REGIONAL DISTRICT OF OKANAGAN-SIMILKAMEEN

CAMPBELL MOUNTAIN SANITARY LANDFILL AND OLIVER LANDFILL OPERATIONS

RDOS-21-FIN-11

ADDENDUM NO. 2

4.4 Maintenance on Open Ditching

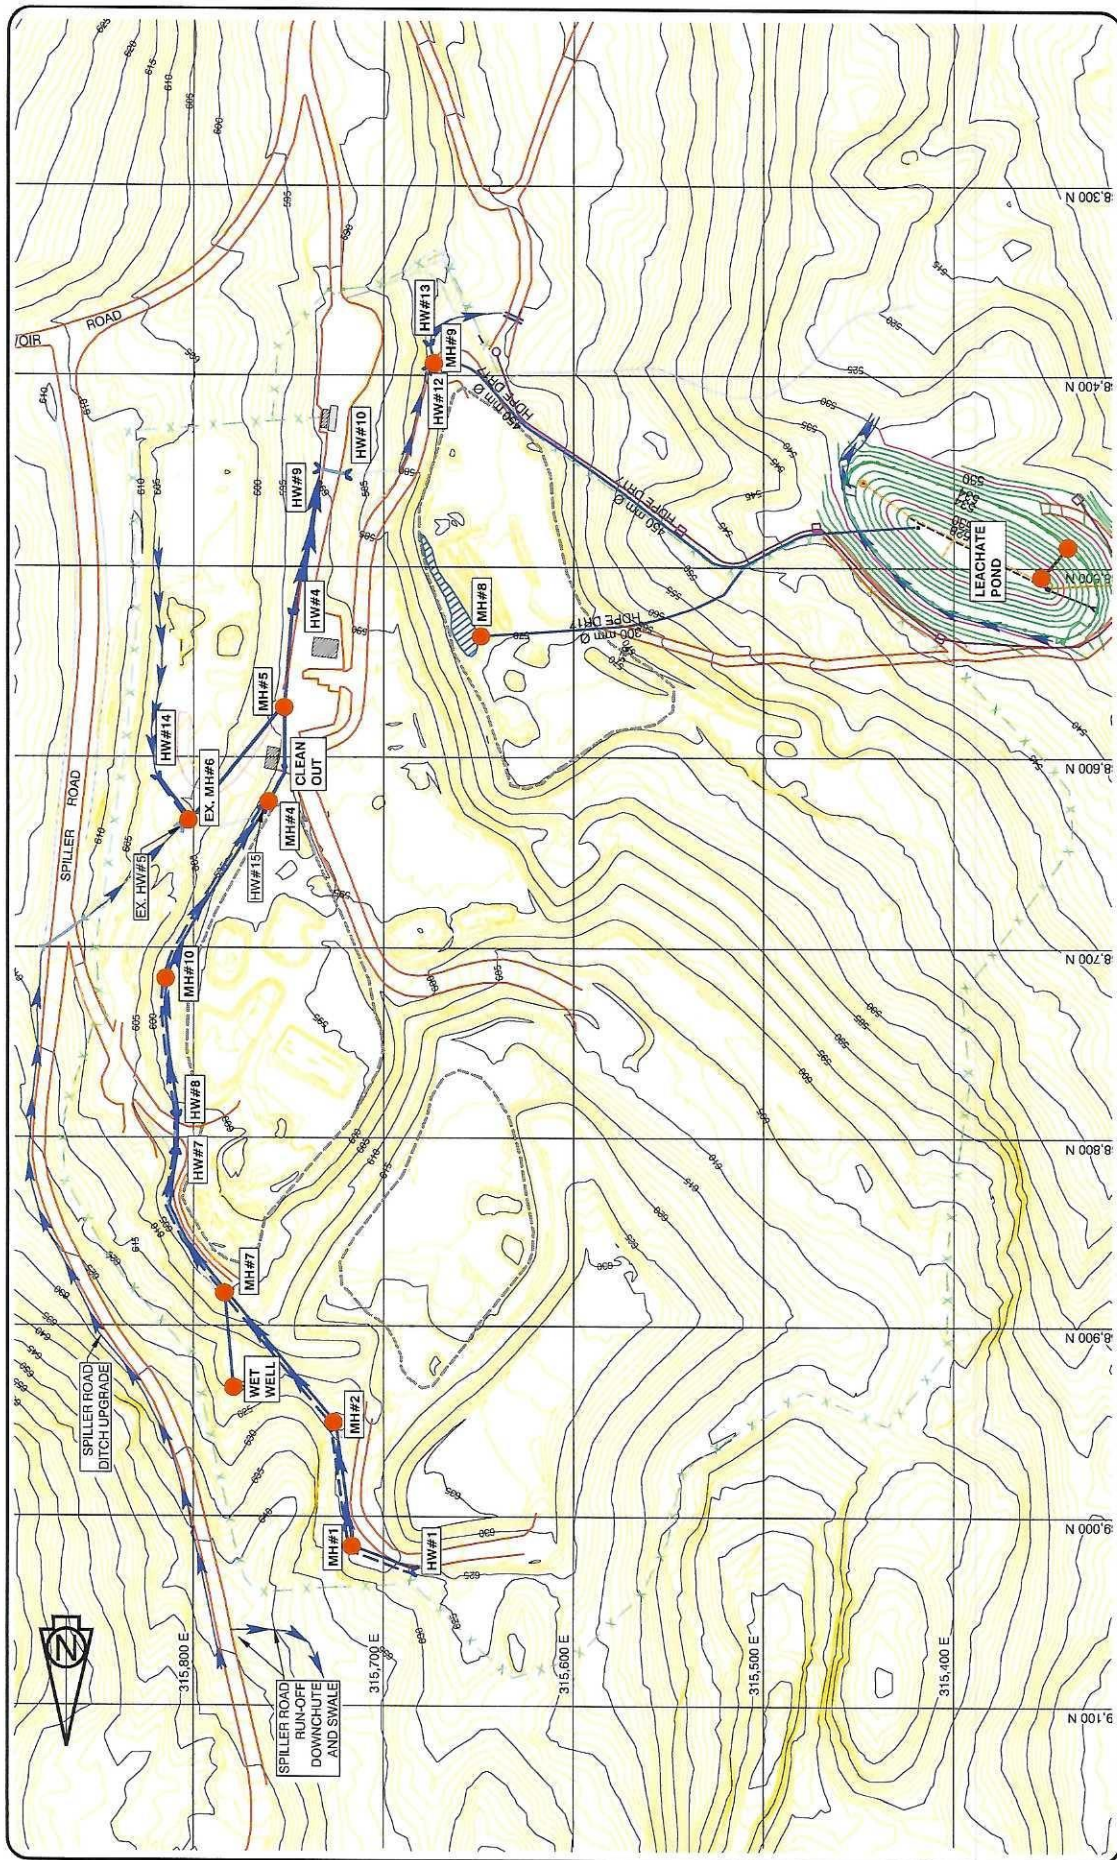
Question: A follow-up to the question in Addendum No.1: *The CMLF has water diversion ditches as well as road ditches. Please clarify whether the water diversion ditches are included.*

Answer: As stated in Addendum No.1, all ditches, including diversion and road ditches, on the Landfill Site are included in the Base Operations. A drawing of the ditch locations was also to be included but was missed before the addendum's release. The last three pages of this addendum are taken out of the 'Campbell Mountain Landfill Operations Manual for Drainage Network and Pond' and provides the drainage ditch layout and maintenance requirements.
